161 LOWELL ROAD – FRIARS COURT SUBDIVISION & SITE PLAN

STAFF REPORT

SB# 02-19: Conceptual Subdivision Plan Application, prepared by The Dubay Group, Inc., 84 Range Rd., Windham, NH 03087, for Dakota Partners, Inc., 1264 Main St., Waltham, MA 02451, dated April 29, 2019, last revised June 5, 2019, and consisting of 33 sheets.

SP# 03-19: Conceptual Site Plan Application, prepared by The Dubay Group, Inc., 84 Range Rd., Windham, NH 03087, for Dakota Partners, Inc., 1264 Main St., Waltham, MA 02451, dated April 29, 2019, last revised June 5, 2019, and consisting of 33 sheets.

SHEET TITLE:
**SITE
LAYOUT
PLAN**

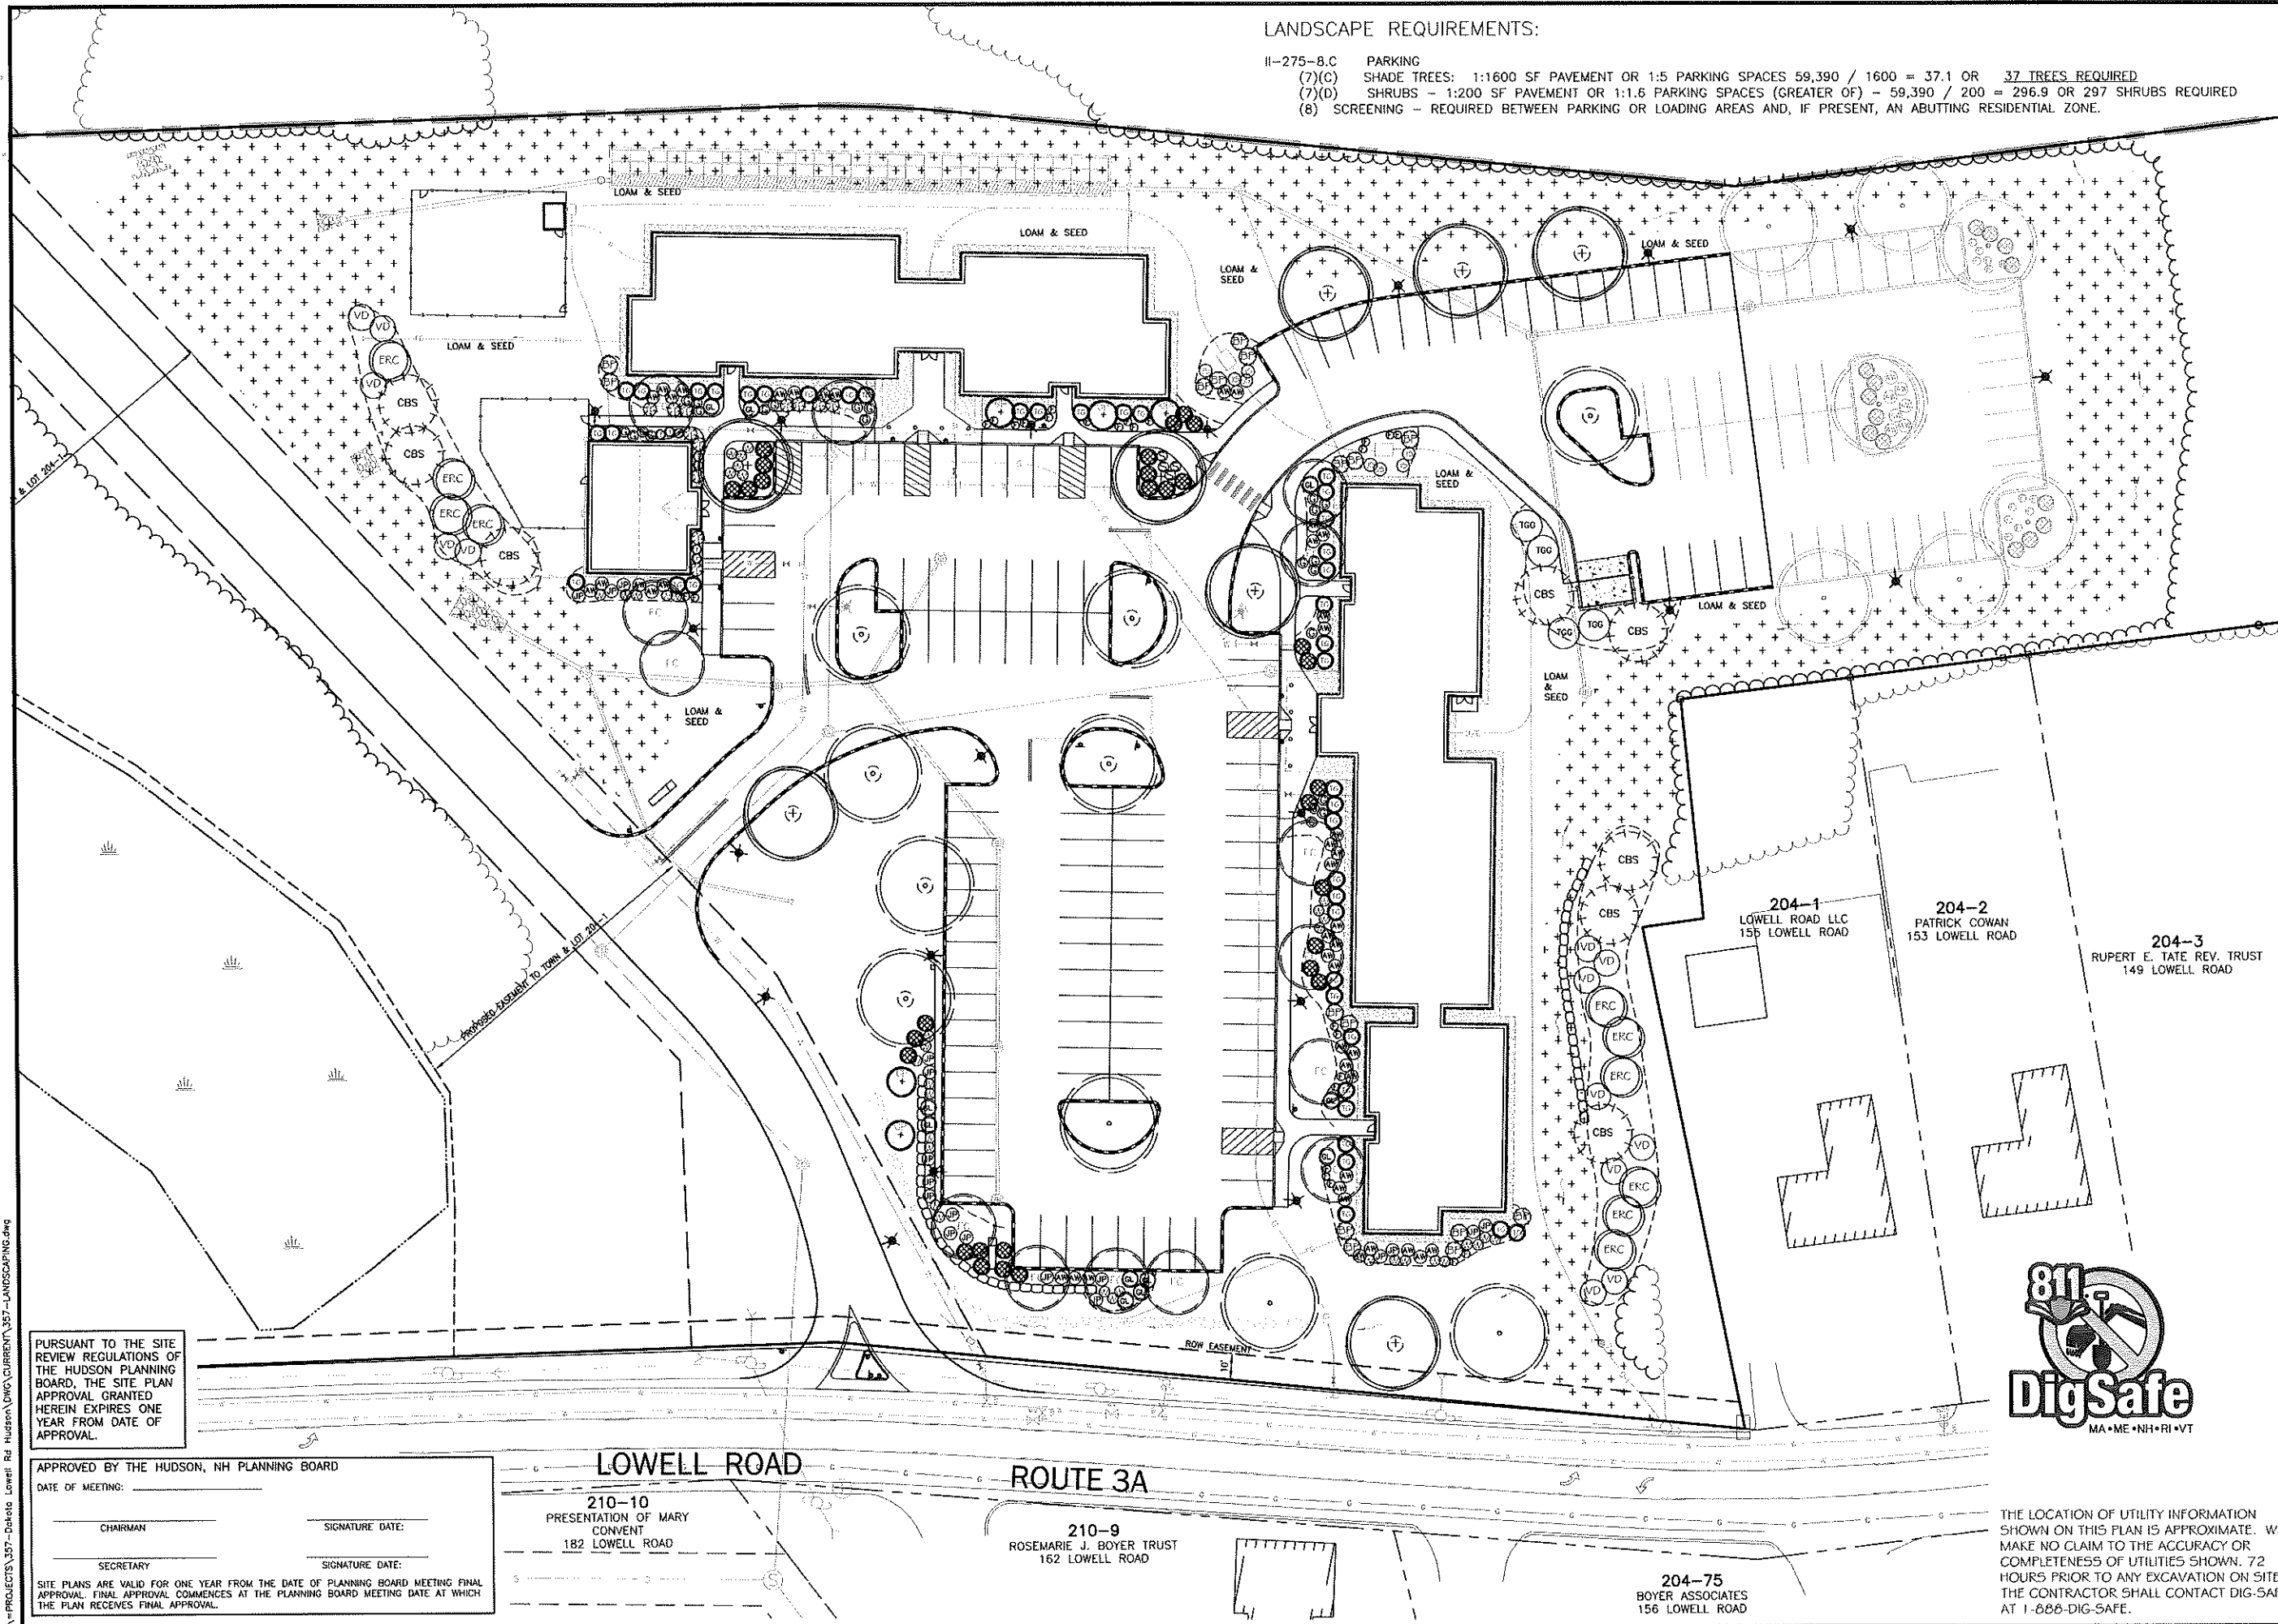
- n. HR 276-11.1.B.(12). The applicant has proposed a portion of the building #1 parking area within the building setback. Also, note #4 on plan sheet #9 shows this setback to be 30 feet where 50 feet is required by Ordinance.

- c. ZO 334.27. The applicant should correct note #4 on sheet #9 which states the front setback to be 30 feet, where 50 feet is required by the Ordinance.

- 6.c Front Setback – Typo will be corrected on Note 4 Sheet 9 (plan information complies).
 - 6.d Density Calcs – Comment verifies buildable lot area calculations.
